Manly Council

Land Use Management Committee

REPORT: **Environmental Services Division Report No. 69**

SUBJECT: **9 Seaview Street Balgowlah - DA81/08**

6470
2760
GAMES
LINE OF FLOOR OVER
Proposed Dwelling
No. 9 Seaview Street,
Balgowlah NSW 2093
Ms. M. Cachia
SKETCH 1 - GROUND FLOOR 24 JULY 08

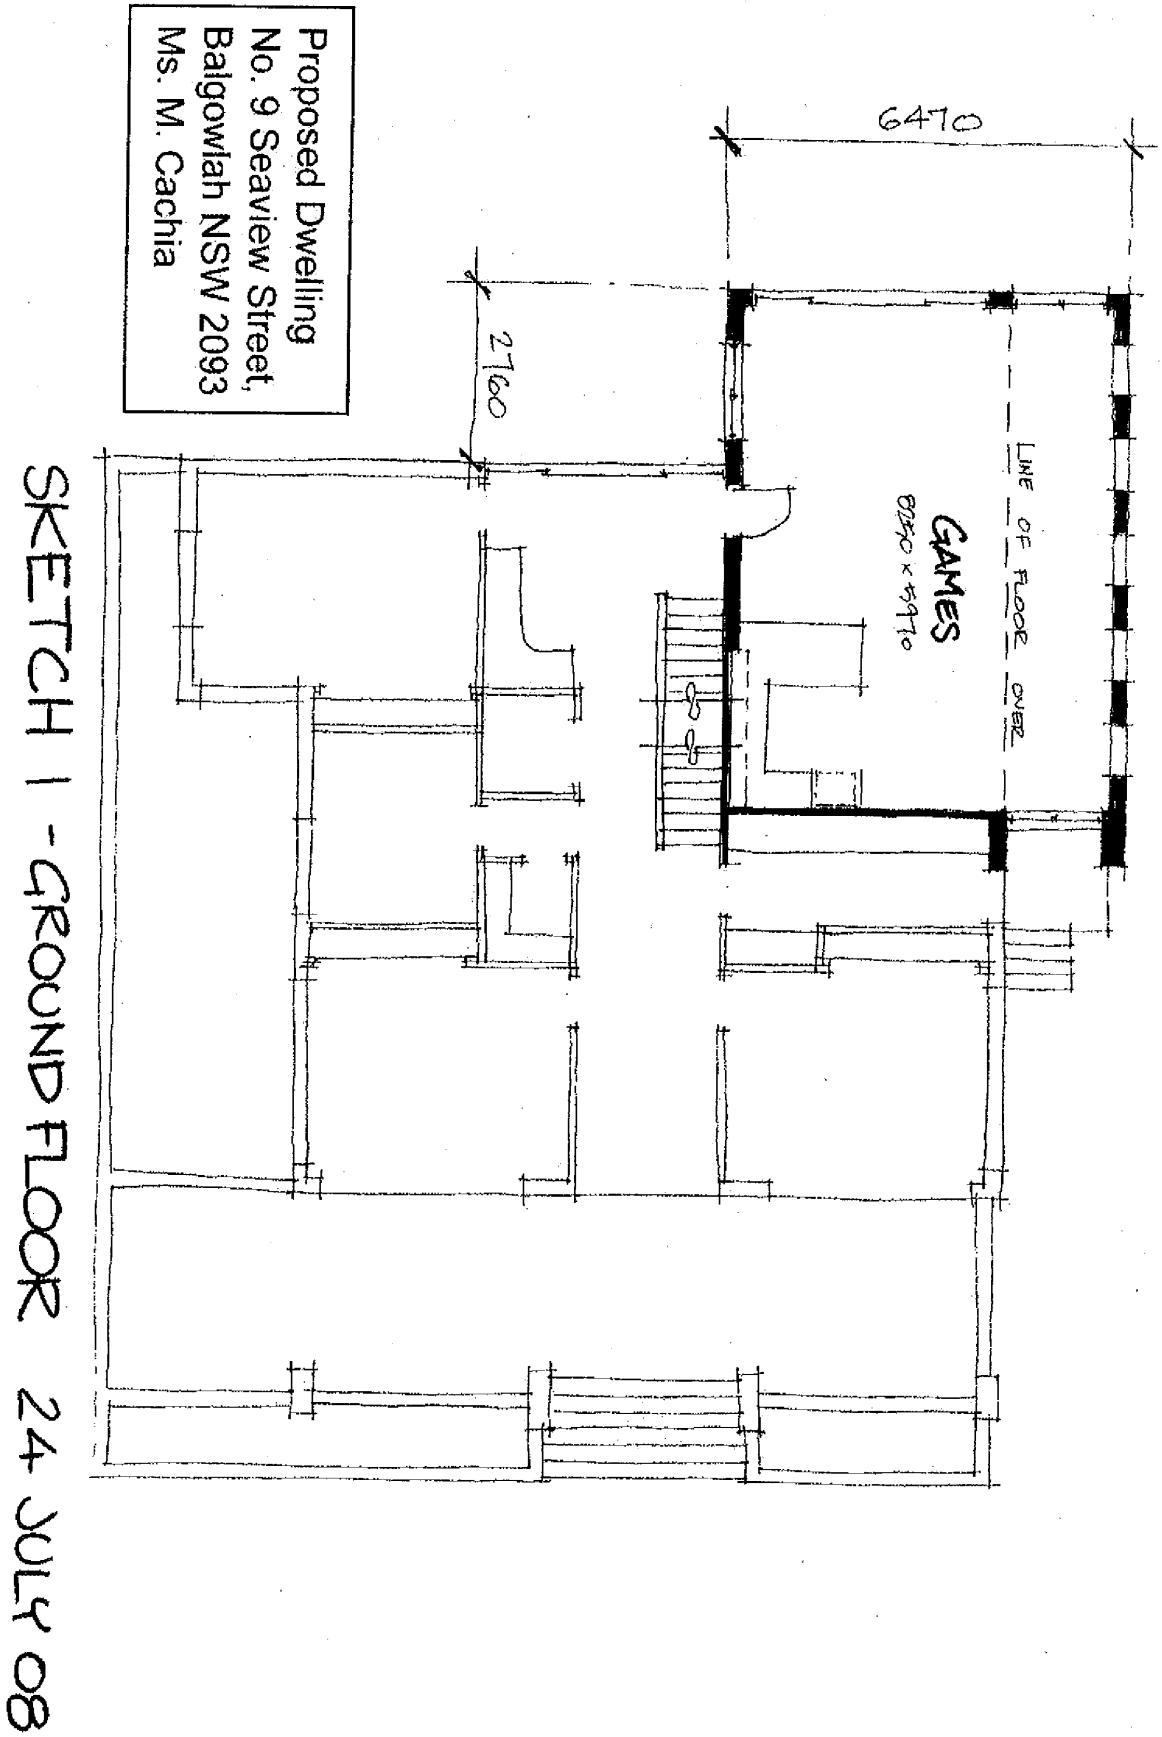
The applicant proposes to replace lost bathroom and bedroom space in Bedroom 1 by having a 2760mm x 4550mm addition to the western (rear) side. This will encroach into the 8.0m rear yard by 2760mm, but is considered acceptable as the adjoining properties on either side has lesser rear setbacks than the proposed dwelling house. It is also proposed to extend the games room on the ground floor to be in line with the rear addition on the first floor. This will result in an increase of the floor area by 12m2. This is acceptable as the addition is at the rear of the dwelling. The width of the dwelling has been reduced and the views from the rear properties will be improved as compared to the original proposal.

4550
2760
ENS
BED 1
4010 x 4200
R
Proposed Dwelling
No. 9 Seaview Street,
Balgowlah NSW 2093
Ms. M. Cachia
SKETCH 2 - FIRST FLOOR 24 JULY 08

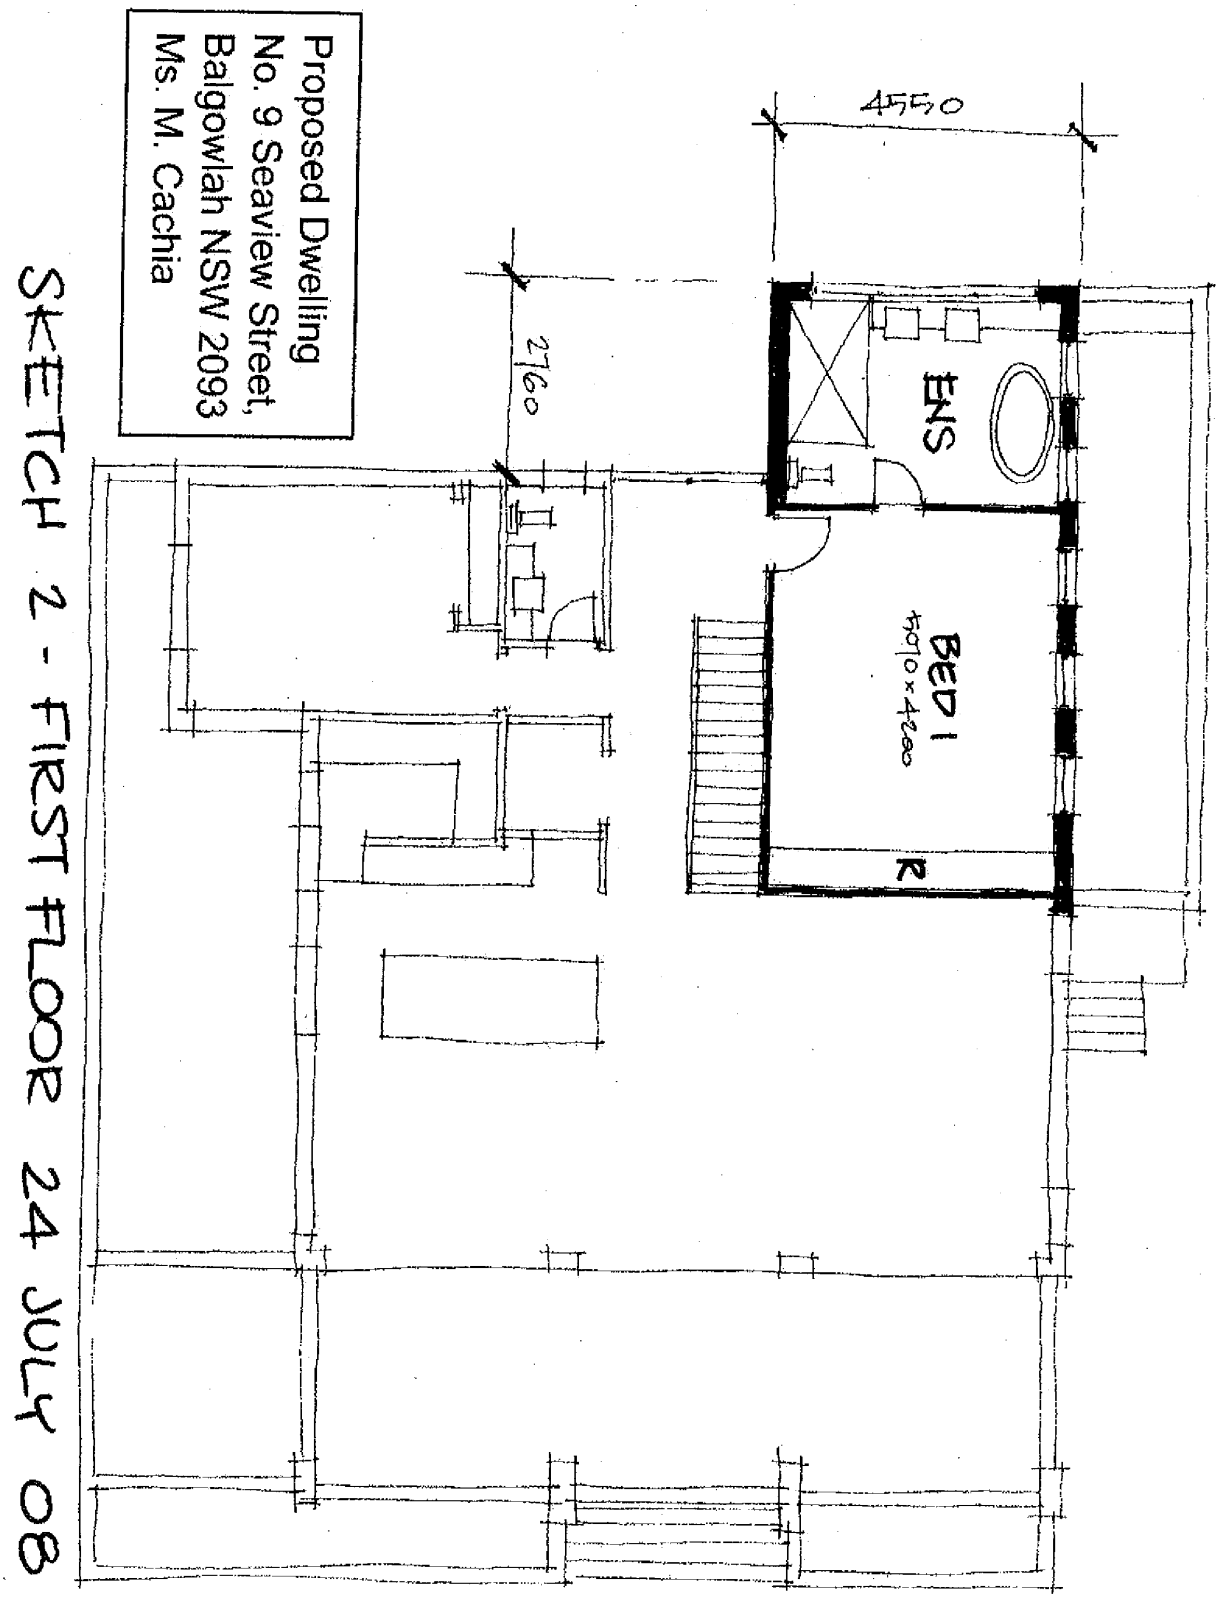
It is noted that the proposal is fully compliant in both side setbacks and wall height. However, following the concerns raised from the adjoining owners, the applicant has submitted a sketch of a possible amendment to address the concerns. The sketch showed an increase in the northern side setback of the rear first floor Bedroom 1. This increase in the setback will improve the view/outlook from the first floor bedrooms of No.10 Wanganella Street. The sketch shows the northern wall of the Bedroom 1 moved back approximately 2.0m. This wall will be in line with the wall of the lounge room on the first floor. The view of St Patrick's Church from No.10 Wanganella Street will not be retained, but the increased setback affords some view of the water. This additional setback will also improve the view corridor of No.12 Wanganella Street.

ANS01
In order to improve the view/outlook from the adjoining properties to the rear, the northern wall of Bedroom1 on the first floor be set back to the line of the lounge and to be at least 4.3m from the northern boundary. The western wall of Bedroom 1 on the first floor and of the games room immediately below on the ground floor be allowed to encroach into the rear boundary in accordance with Sketch Nos. 1, 2 & 3 dated 24 July 2008 and received by Council on the 25 July 2008 plans be amended prior to the issue of the Construction Certificate.

ANS02
In order to protect the privacy of the adjoining properties to the rear, the window of the bathroom in Bedroom 1 be high windows and the sill to be at least 1600mm above the finished floor level of the bathroom.
